Planning Commission Study Session

SUBJECT: DR19-169, SUPERSTAR CAR WASH

DR19-169 SUPERSTAR CAR WASH: Site plan, landscape, grading and drainage, elevations, floor plans, lighting, colors and materials, for approximately 1.39 acres, generally located on the northeast corner of Val Vista Dr. and Riggs Rd., and zoned Shopping Center.

LANDSCAPE LEGEND

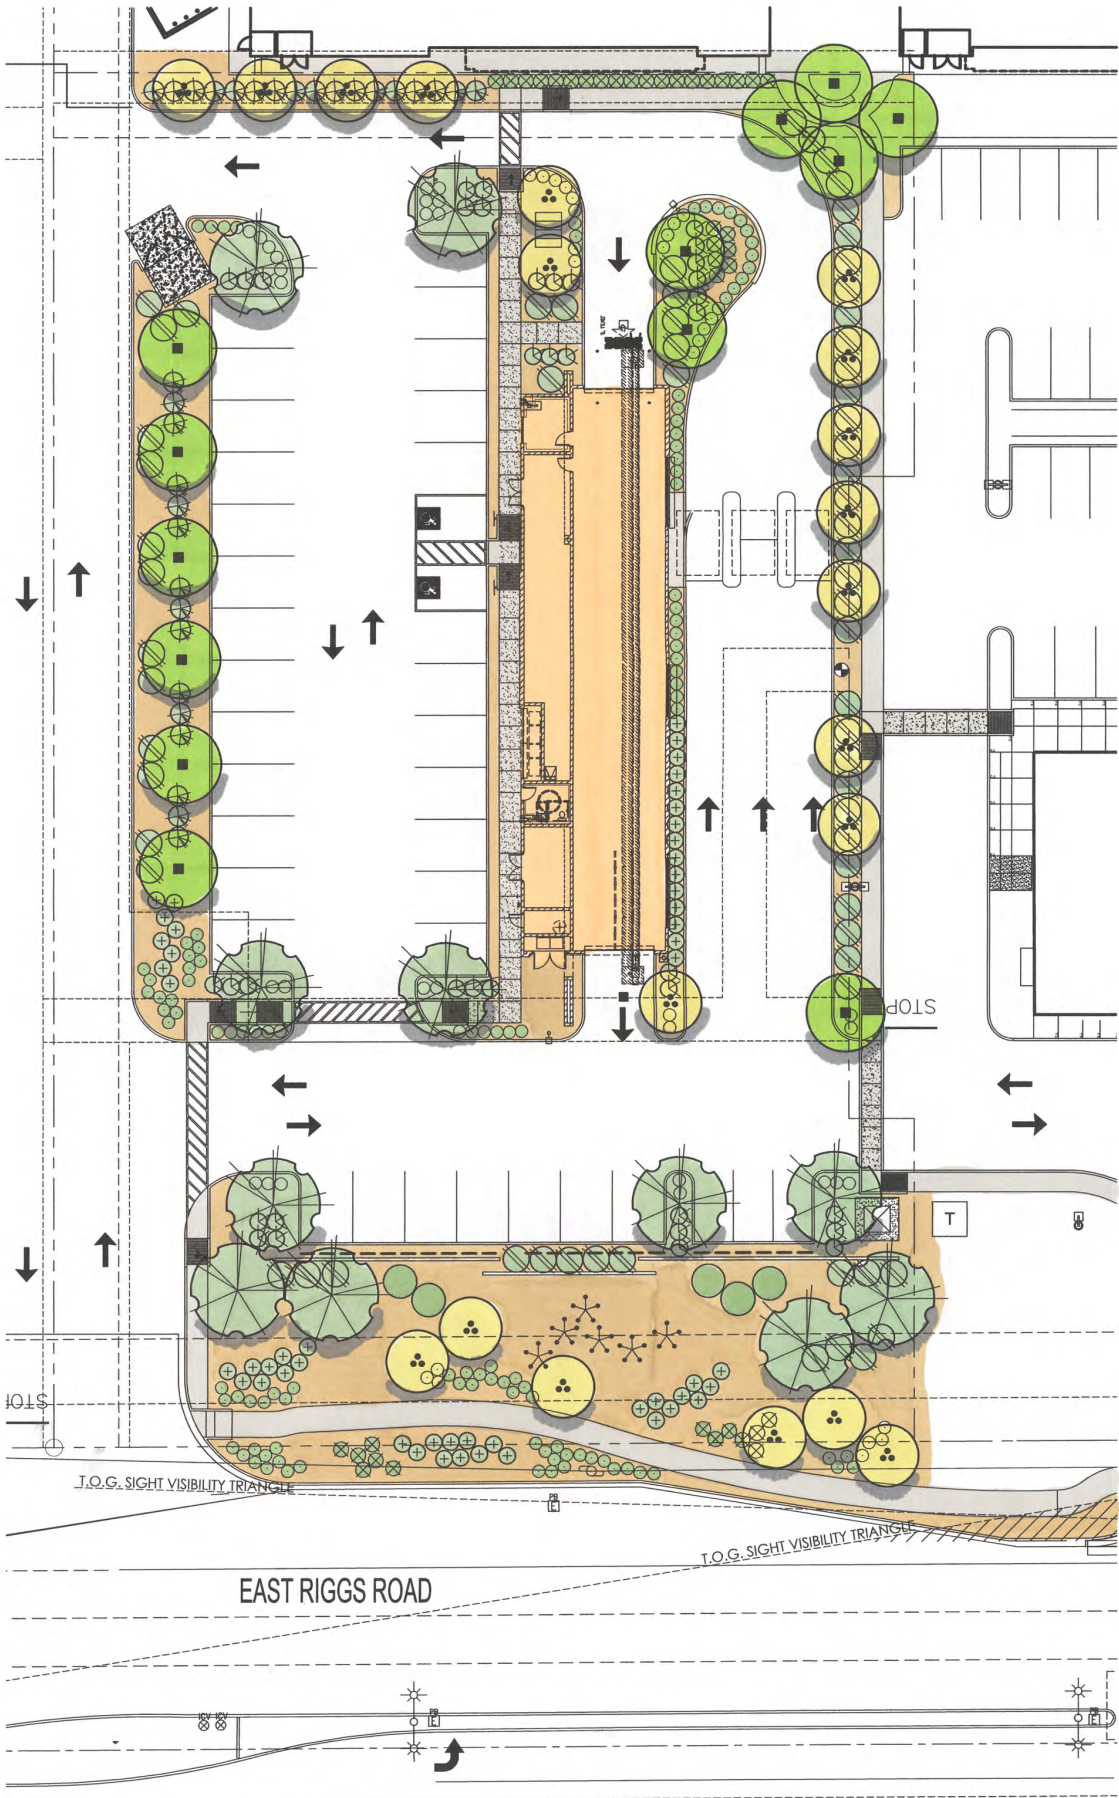
The landscape palette for Phase I is generally consistent with the surrounding uses by including Desert Willows, Red Push Pistache, Hybrid Mesquites, Pink Oleander, Red Yucca, and other desert landscaping. Superstar Car Wash has proposed a slightly different landscape palette consisting of Chinese Elms, Thornless Mesquite, Virginia Live Oaks, Yellow Bells, other various shrubbery. Staff has requested the applicant's chosen landscape palette become more consistent with the plant palette approved in Phase I, especially along the right-of-way.
